T-14240

Groundwater Transfer Review Summary Form

Transfer/PA # T- 14240

GW Reviewer Gabriela Ferreira Date Review Completed: December 19, 2023

T-14240, Westwood Farms, Inc. T6S, R3W

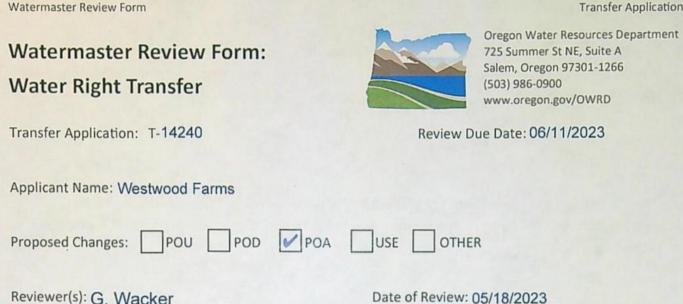
Yes ⊠ No Comments: Several wells were identified near the proposed POAs that could be affected by the proposed change, including MARI 4801, MARI 4851, and MARI 4799, which are all completed to depths less than 50 feet bls. The currently authorized POAs, MARI 4848 and proposed APOA MARI 4850 are completed to depths of 40 and 44 feet bls respectively. The proposed POA Well 2 would be completed to a depth of 110 feet bls. Therefore, the POAs and nearby wells that will likely be affected by the proposed use do not fully penetrate the sedimentary aquifer in this area, which the USGS estimates at ~600-650 feet thick (Gannett and Caldwell, 1998). Consequently, injury due to the proposed change would not be found because the potentially-affected well(s) do not fully penetrate the shared aquifer (OAR 690-008-0001(8)(c)).

☐ Yes ⊠ No Comments: <u>The currently authorized POA MARI 4848 is approximately</u> 8,000 ft from the nearest perennial surface water source (Willamette River). The proposed modification to the location of Well 2 is approximately 250 feet east of the currently authorized location; proposed APOA MARI 4848 is approximately 650 feet southeast of authorized POA MARI 4850. The shallow wells (MARI 4848 and MARI 4850) are constructed within Holocene gravel deposits from the Willamette River floodplain. In general, these deposits have a saturated thickness of 20-40 feet and the water level is closely tied to stream stage in the Willamette River (Conlon et al., 2005). The relatively small changes in distance between authorized POAs and proposed POA locations to the nearest perennial surface water source, at the maximum rate authorized (30 gpm), is unlikely to result in an increase in interference with nearby surface water sources.
